Project	IEEE 802.16 Broadband Wireless Access Working Group < http://ieee802.org/16 >
Title	Improved Stack Diagram
Date Submitted	[2004-03-13]
Source(s)	David Johnston
Re:	Sponsor Ballot Comment against P802.16-REVd_D3 by David Johnston
Abstract	
Purpose	To furnish the stack layering diagram with the correct interfaces and scope and to define the CS SAP and the ISS correctly.
Notice	This document has been prepared to assist IEEE 802.16. It is offered as a basis for discussion and is not binding on the contributing individual(s) or organization(s). The material in this document is subject to change in form and content after further study. The contributor(s) reserve(s) the right to add, amend or withdraw material contained herein.
Release	The contributor grants a free, irrevocable license to the IEEE to incorporate material contained in this contribution, and any modifications thereof, in the creation of an IEEE Standards publication; to copyright in the IEEE's name any IEEE Standards publication even though it may include portions of this contribution; and at the IEEE's sole discretion to permit others to reproduce in whole or in part the resulting IEEE Standards publication. The co

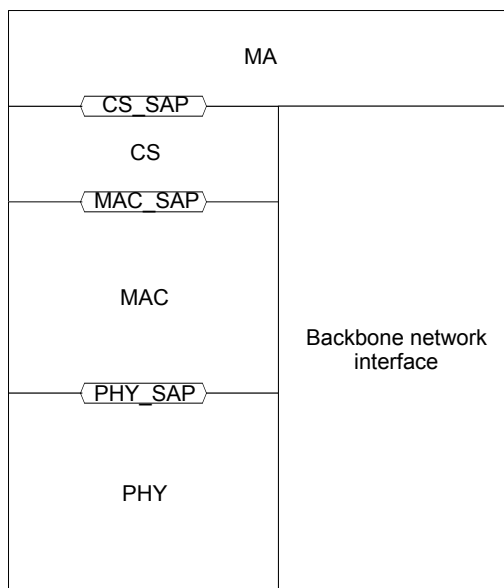
These diagrams have some interesting properties.

The CS in 802.16e does not have a CS_SAP. In both 802.16d and 802.16e, no CS_SAP primitives are defined. Instead, the packet CS specification has frames (IP, 802.1Q or 802.3) passing upwards and downwards out of and into the CS. The ATM CS does something similar with ATM connections. Each CS type and subtype defines a mapping between the frames and the MAC_SAP primitives.

In 802.16e, a CS_SAP has appeared as an interface between the CS and MA (Mobility Agent). The mobility agent is drawn as a bridging layer, between the CS and some other undefined backhaul network. There is no MA_SAP, nor is there any other type of service defined. 802.16e in this mode is either a network tunnel using the chosen CS protocol type (ATM, IP, 802.1Q or 802.3) as the encapsulating protocol.

Unfortunately, since no CS_SAP primitives are defined, so the model is incomplete.

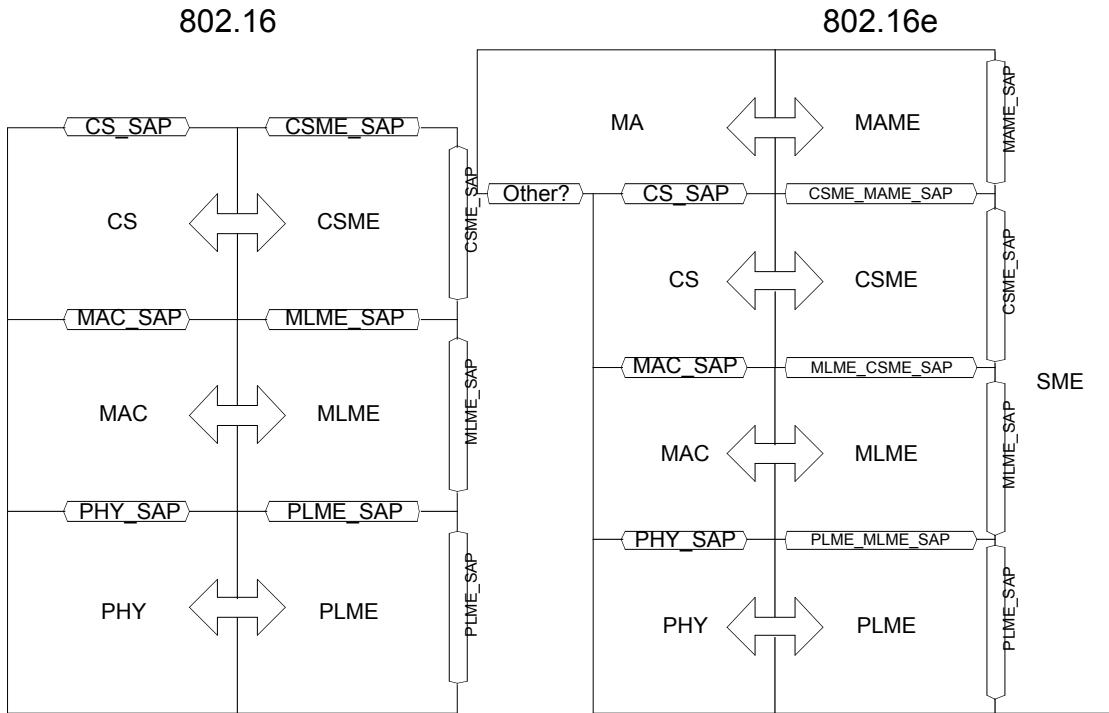
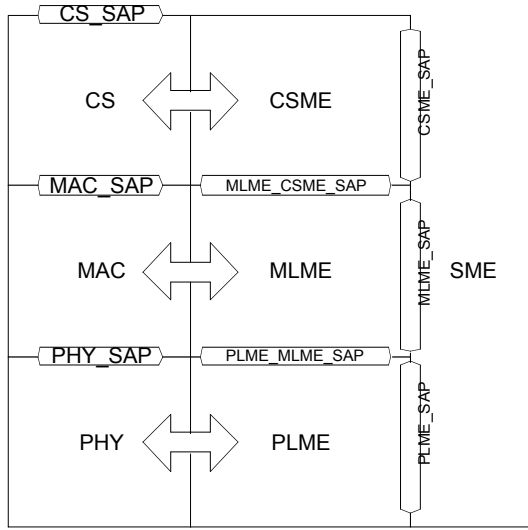
The 802.16e model still has problems. The MA is still defining the BS as being a bridge. There can be no services available at the top of the stack, since there is no upwards data SAP. There needs to be a separate MA defined for each CS.

The MA is defined as being something in the data path. This seems odd, given that an MA usually is concerned with making handover decisions and in some way managing a handover and address mapping. In general it looks like a management function.

In the specification, there are no specific procedures assigned to the MA, so it would be inappropriate for it to exist as a layer in the data stack. Hypothetically it should exist in the SME as an implementation defined function that will be related on the larger system architecture of the BS or MSS. The way that the MA can interact with the stack is through the CSME_SAP, MLME_SAP and PLME_SAP.

What should we do? Well for a start, we need to 'close' the layers. All interaction between a layer and anything else should be through SAPs. This means a CS_SAP with defined primitives, one set for each of the CS types.

To draw from the experience of other wireless standards, we could add in a structured management stack, with its own SAPs to formalize the scope of management behavior and the way it interacts with other entities.

So for both 802.16 and 802.16e, we can naively add a management stack and interfaces and we get the following:

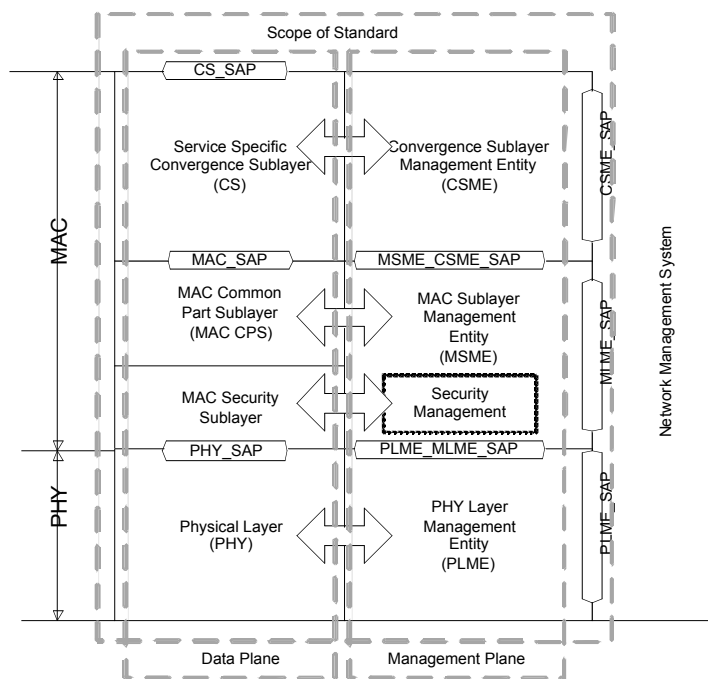
5
 6 So bringing in the extra information from figure 1 concerning the scope of the standard and the location of the data and
 7 management planes and renaming some of the 802.11 derived names to bring them into line with 802.16 terminology, I
 8 propose the following be substituted for figure 1.

9
 10
 11 The CS SAP does not need describing directly. It can be described by reference to 802.2. This is in “**2.3 LLC sublayer/MAC
 12 sublayer interface service specification**”
 13 It defines the following primitives..

16 Thus we need only an IP and an 802 mode for the packet CS. We do not need separate 802.1Q and 802.3 modes in the CS.
